## Application for works approval

**Works approval number** W6342/2020/1

**Applicant** Mt Magnet Gold Pty Ltd

**Premises** Mt Magnet Gold  
Mining tenements M58/121, M58/193 and M58/205  
MOUNT MAGNET WA 6638

Figure 4 Stormwater drainage and topography

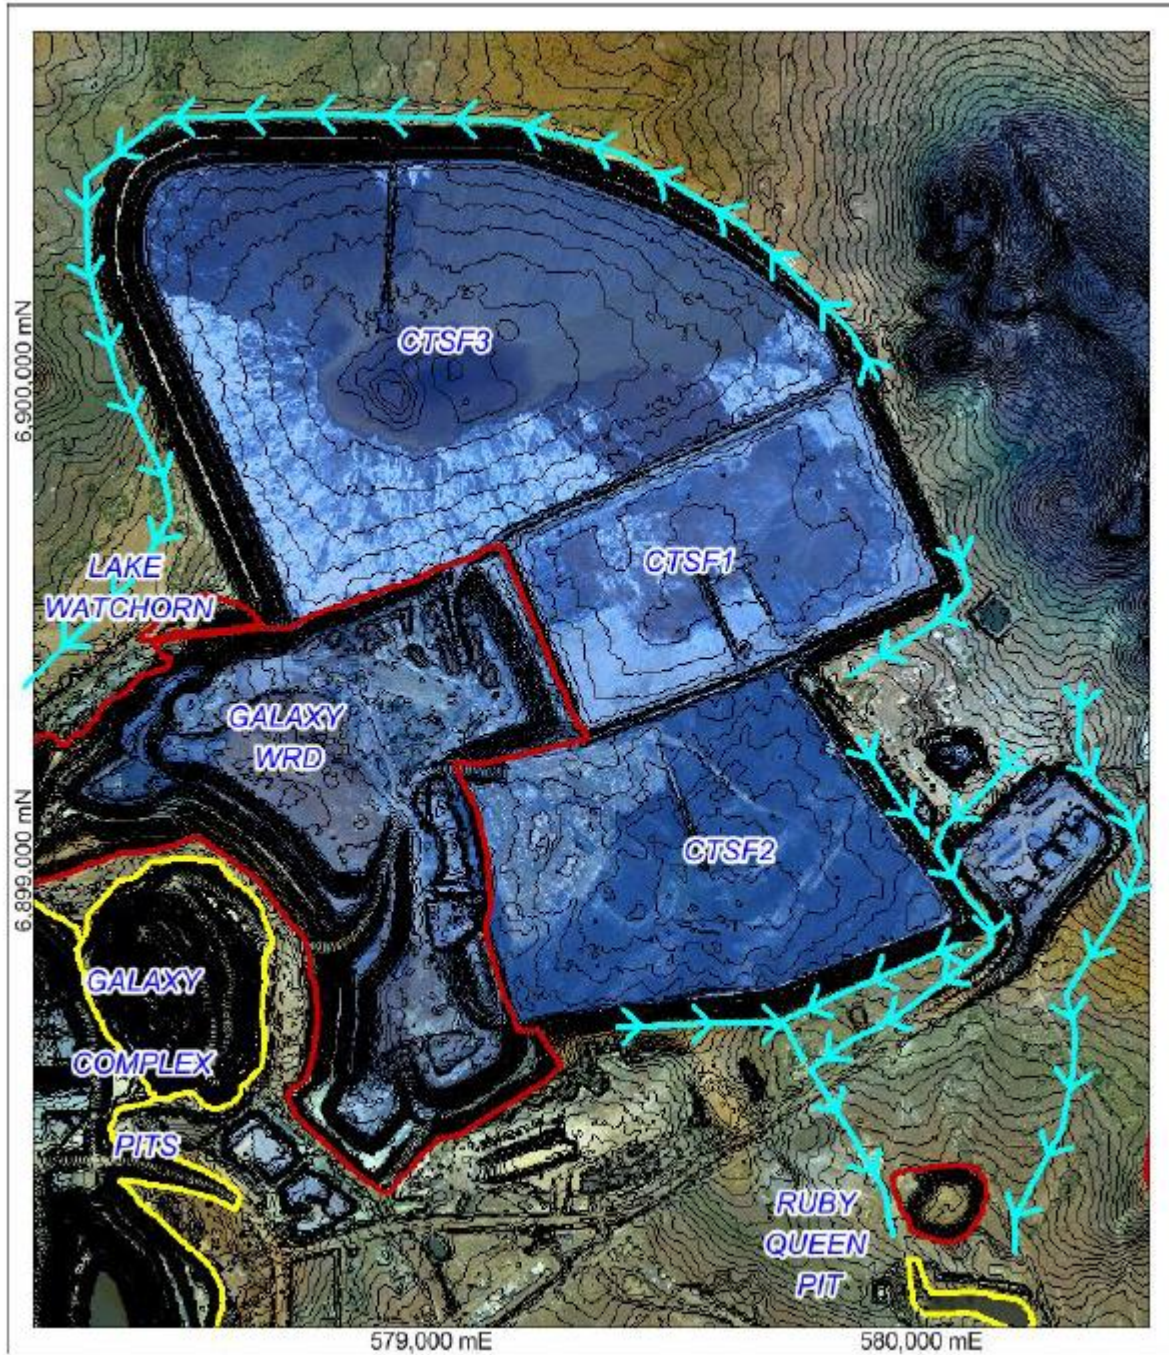
It is also noted in application documents that flow paths are contained by the Galaxy complex pits (Figure 4). A review of the application documentation by the department's Principal Hydrogeologist suggested not all seepage may be captured by pits, and that there is potential for dense, saline groundwater staying near the base of the regolith, flowing along an inclined bedrock surface by gravity.

Figure 5 Groundwater bores with relevant historical data available. Red underlined monitoring bores have been destroyed or are not operational anymore.

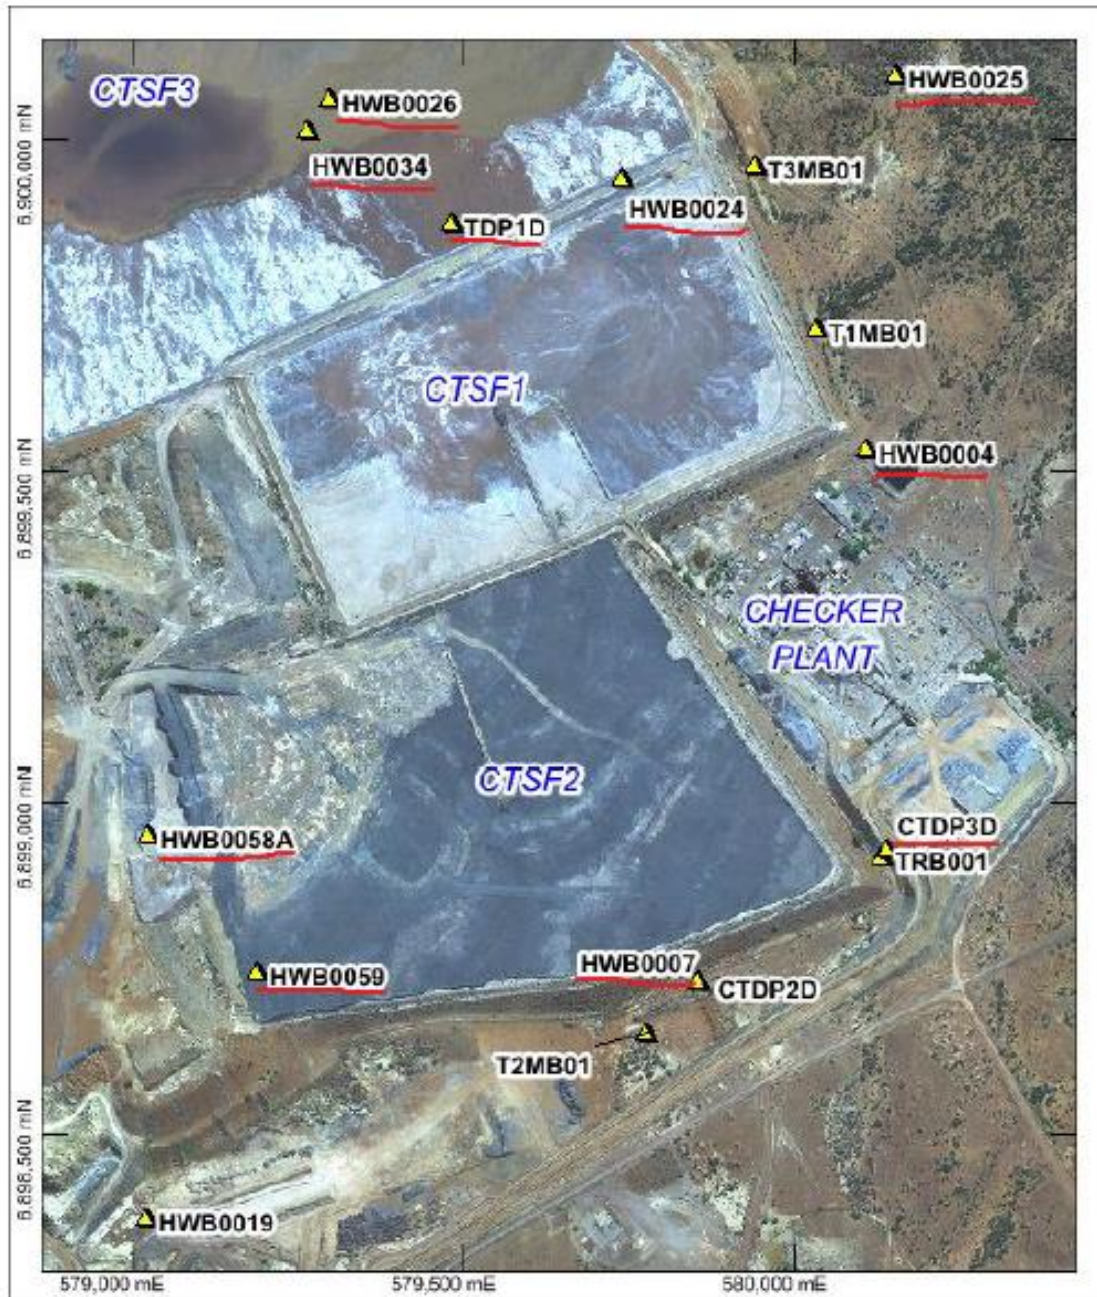
Current groundwater monitoring is focused on capturing impacts of operational CTSF3, and is less comprehensive for seepage impacts from historical use of CTSF1 and CTSF2. The applicant provided a map showing groundwater bores with relevant historic monitoring data available (Figure 5). Further correspondence (Correspondence 22 April 2020) confirmed the majority of these bores have been destroyed or are not operational anymore (Table 5), limiting the extent of the existing borefield for all CTSF's onsite.

Historical data indicated multiple bores were detecting seepage from CTSF1 and CTSF2 during operations. CTDP1D, CTDP2D and HCB058 showed increased salinity and detectable cyanide, directly linked to tailings seepage impacts. Bores CTDP3D/TRB001 had an increase in salinity but not cyanide, and impacts are possible but not confirmed (MWES Consulting, 2019).

Internal technical advice identified that proposed monitoring bores are targeting different depths which results in inconsistent monitoring results. T1MB01 in particular appears to be too shallow and is dry most of the time. These proposed monitoring bores are not adequate to monitor seepage impacts. After review of the provided data, the department's Principal Hydrogeologist suggested the contaminant is moving at the base of the regolith, along the surface of fresh bedrock. Therefore this would be a more appropriate depth interval to monitor. It is recommended that the applicant consider this in further detail before the installation of any additional monitoring bores so that any new bores are appropriately placed and installed.

For the embankment raises and reinstatement of CTSF1 and CTSF2, an appropriate groundwater monitoring network is required to be established. The proposed bores (section 5.1.3) have been found to be unsuitable for this purpose. An adequate amount of monitoring bores with representative depth and location are necessary to identify potential seepage impacts. Monitoring bores are required to be placed in near proximity of CTSF1 and CTSF2, as well as to the west side of the Galaxy pits to detect any potential seepage not captured by the presumed geological barrier to the PDWSAs.

As this is a matter of urgency, the groundwater monitoring bores are required to be completed within 1 month of issuing this works approval. In addition, the premises requires adequate seepage management measures. Seepage infrastructure is required to be completed within 6 months of issuing this works approval.

Figure 7 Monitoring and recovery bores at the premises

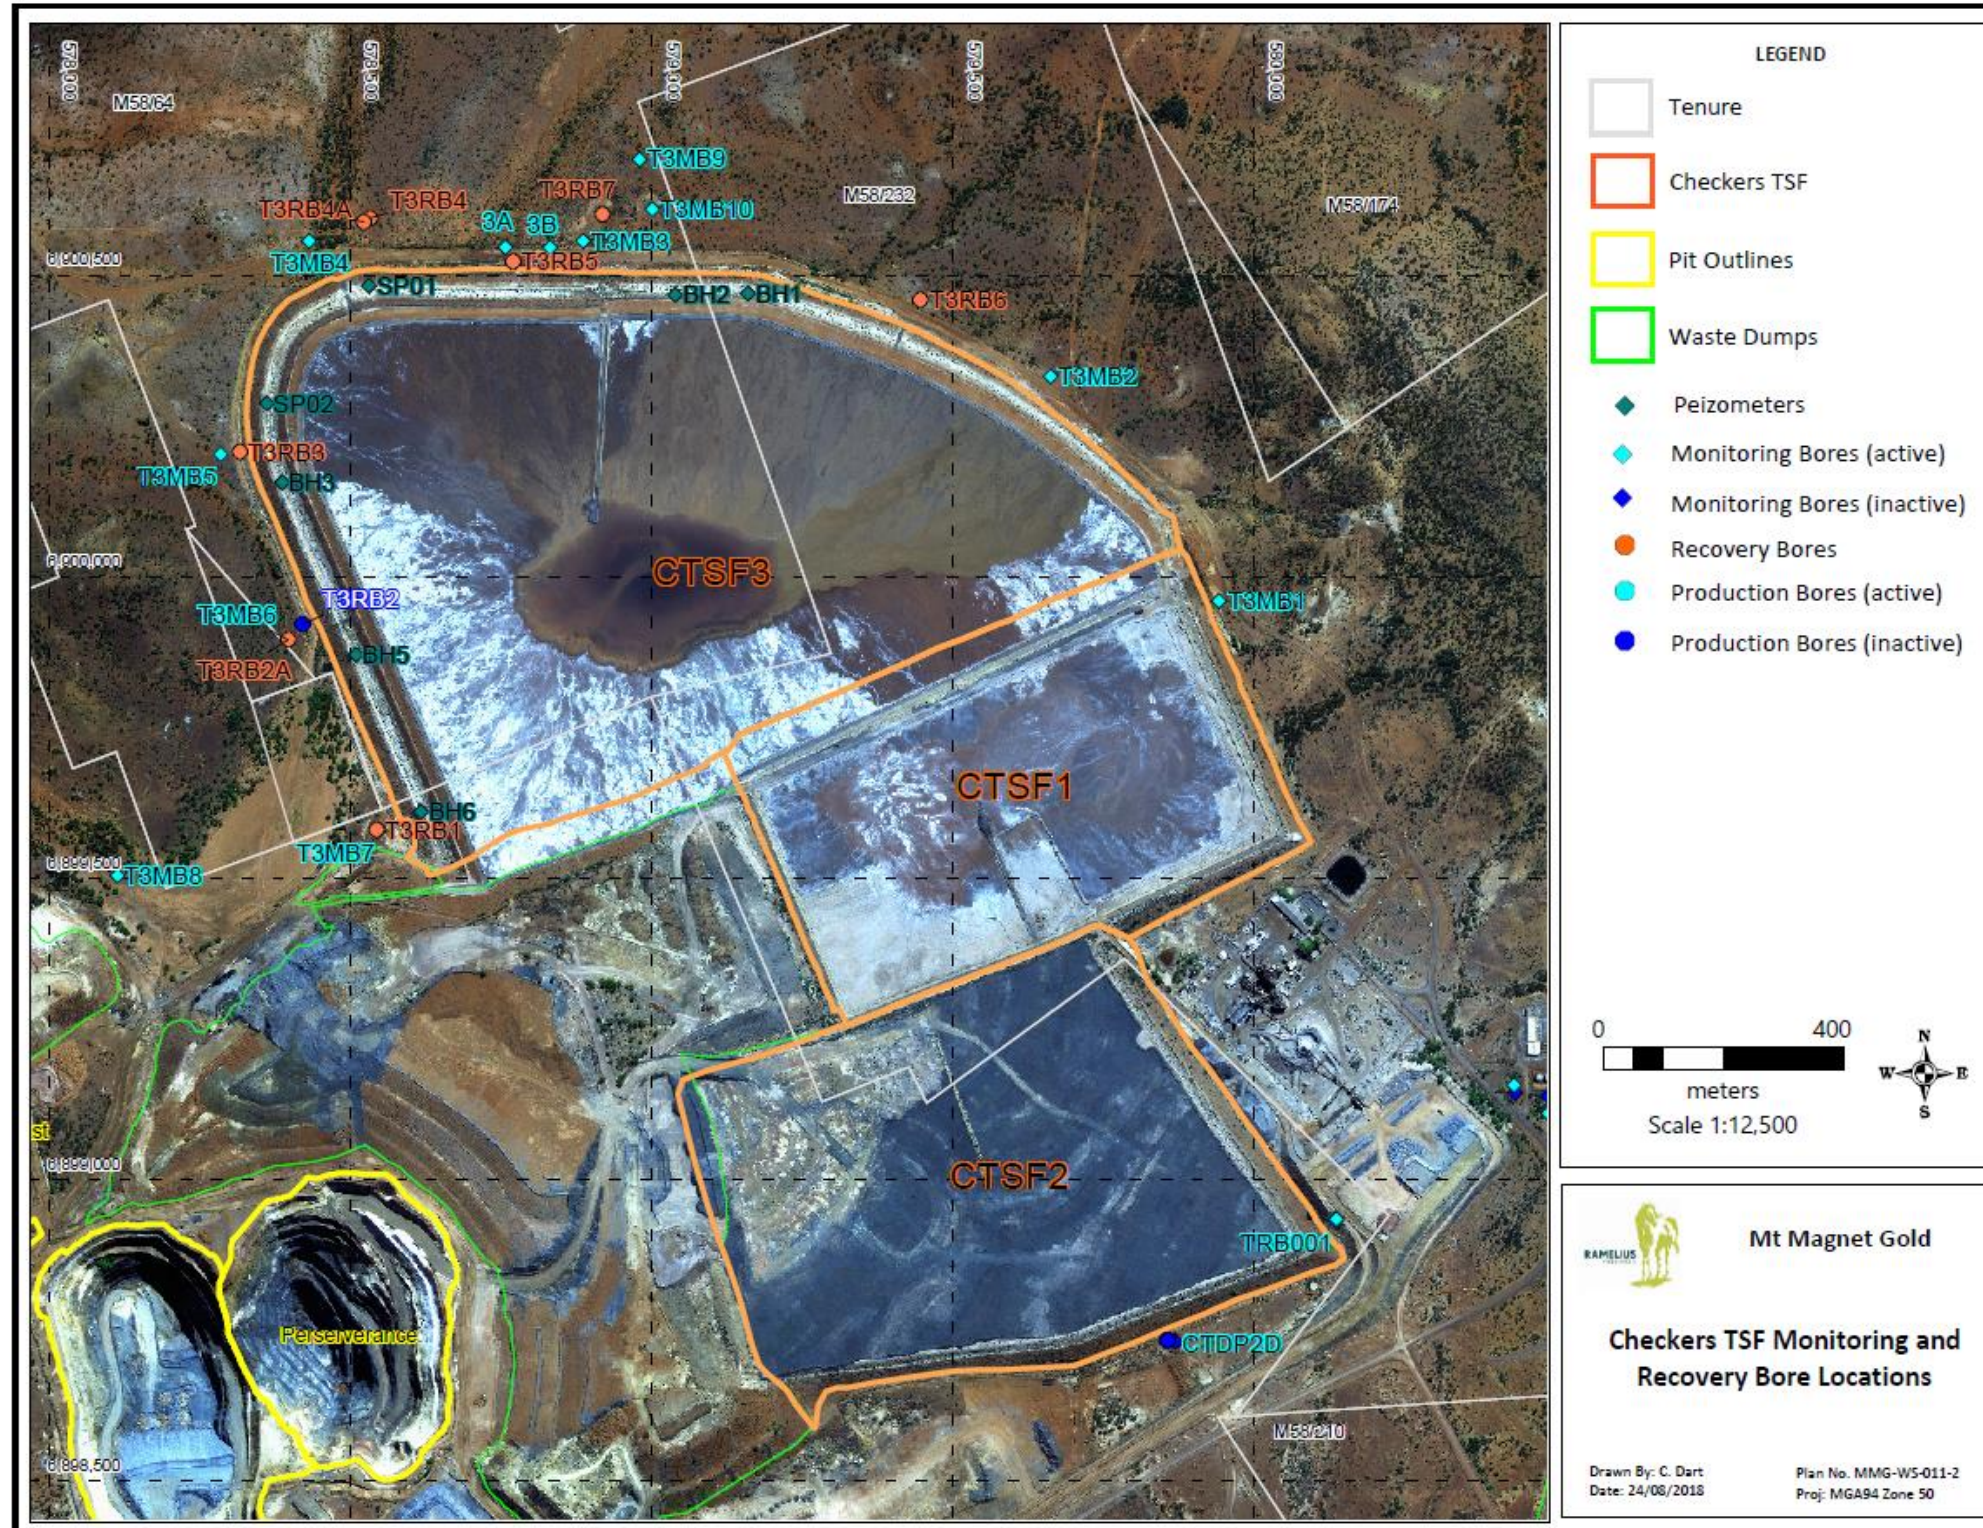
Other seepage management infrastructure consists of recovery bores, which are located on the western and northern side of CTSF3 (Figure 7). It should be noted that no record of recovery bore labelled on Figure 7 as T3RB5 is available and appears to not exist.

The Annual Environmental Report (AER, 2019) covering operations from 2018 - 2019 submitted to the department as required by the current licence L5529/1988/12, showed cyanide present in most CTSF3 monitoring bores (Figure 7). Any detectable cyanide, and TDS concentrations >10 000 mg/L in the groundwater is considered by the applicant to be from seepage, as set out in Table 6.

It should be noted that only two of the CTSF3 monitoring bores are located at the southern side, below the adjacent to CTSF3 located CTSF2. Therefore limited groundwater quality concentrations are available. The groundwater monitoring bores CTP2D and TRB001 south of CTSF2 both indicate impacts of seepage (Table 8), agreeing with findings in the Electromagnetic Survey discussed below. Findings from the Electromagnetic Survey were made available to the department during the assessment, which indicates extensive seepage at the southern side as described below.

Additional seepage recovery infrastructure needs to be installed, and efficiency of seepage recovery demonstrated. As significant seepage is already occurring, the installation of seepage infrastructure is of high urgency and is to be completed within 6 months of the issuing date of this works approval.

Additionally, monitoring bores at the southern side are required to be installed to get a clear understanding of seepage impacts. Construction and operation of additional monitoring bores are required to be completed within 1 month of issuing this works approval. Based on the Electromagnetic Survey (NEWEXCO 2019) and geophysical data, the contamination is likely moving at the base of the regolith along the surface of fresh bedrock. Therefore this appears to be the most appropriate depth interval to monitor.

**Figure 8 Anomalous zones indicating seepage (NEWEXCO 2019)**

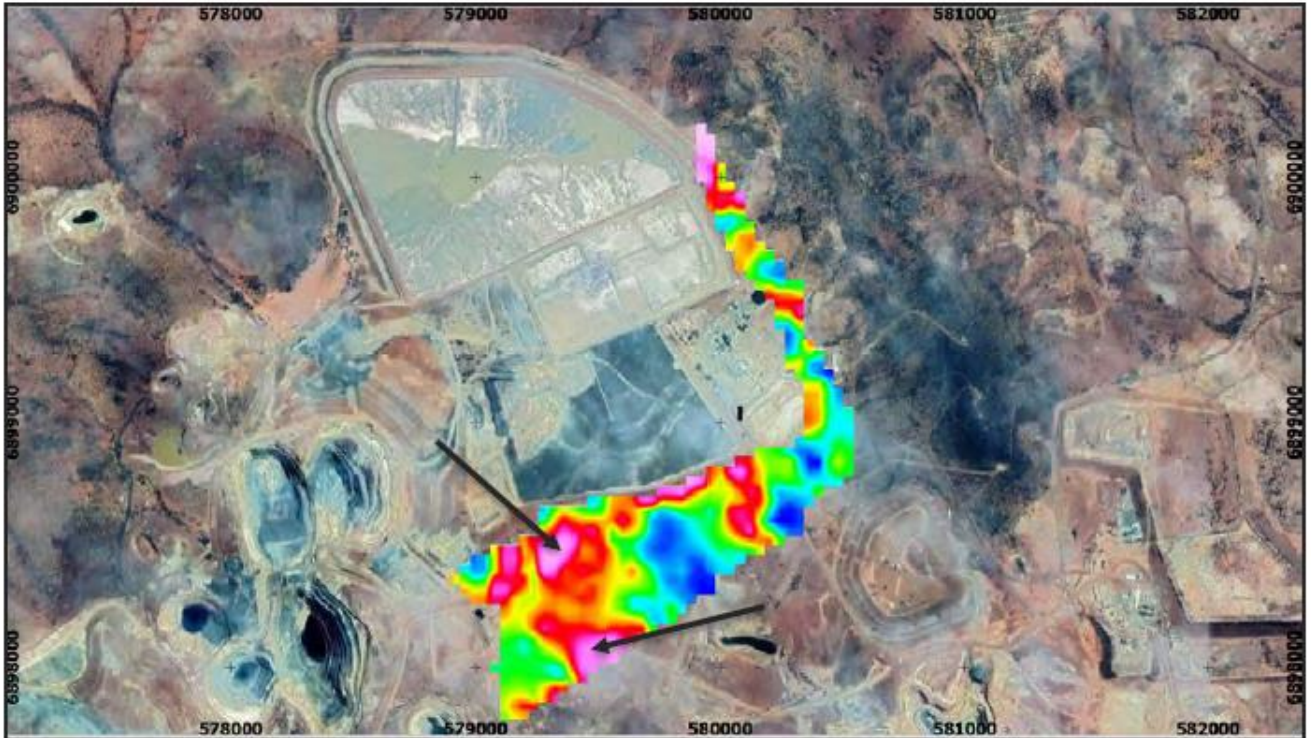
As part of further information requested by the department from the applicant, findings from an Electromagnetic Survey which was carried out 2019, were provided (NEWEXCO 2019). The study identified anomalies at the southern side of CTSF2 associated with increased salinity which appears to be sourced from tailings seepage as suggested in the report (Figure 8). The report compared findings to a survey undertaken in 2012 and concluded that the anomalies have formed in the past 7 years. The installation of recovery bores in those locations of suspected seepage were recommended by NEWEXCO. It should be noted that the applicant does not accept the interpretations and recommendations in the report as stated in further correspondence with the department (RFI 9 April 2020). However no evidence has been provided to the department to suggest otherwise and therefore the Delegated Officer considers the findings of the NEWEXCO report to be valid.

Data from the few groundwater monitoring bores (T3MB1, CTP2D and TRB001) located within the area identified in the NEWEXCO report (Figure 8), agree with suggestions of seepage occurring. A review of the provided data by the department's Principal Hydrogeologist confirmed the necessity of seepage recovery and further investigation of the saline groundwater plumes discharging from the southern wall of CTSF2.

The actual extent of seepage remains unknown and should be considered and investigated further due to the location and proximity to the PDWSAs (Figure 3). It was further advised due to pH and high salinity, to analyse oxyanion-forming metals (chromium, molybdenum, vanadium), arsenic and antimony. Additional technical advice provided by the department's Principal Hydrogeologist raised concerns about the suitability and efficiency of recovery bores, due to low hydraulic conductivity of fractured bedrock and the overlying regolith in the affected area. The applicant should note this and consider the best options for seepage recovery going forward.

In order to permit an embankment raise of CTSF3, the current occurring seepage is required to be investigated, addressed and managed. While the applicant is cautious about the interpretation of the Electromagnetic Survey (NEWEXCO, 2019) suggesting seepage, monitoring bores have indicated seepage in the past. This requires further investigation into the extent of seepage.
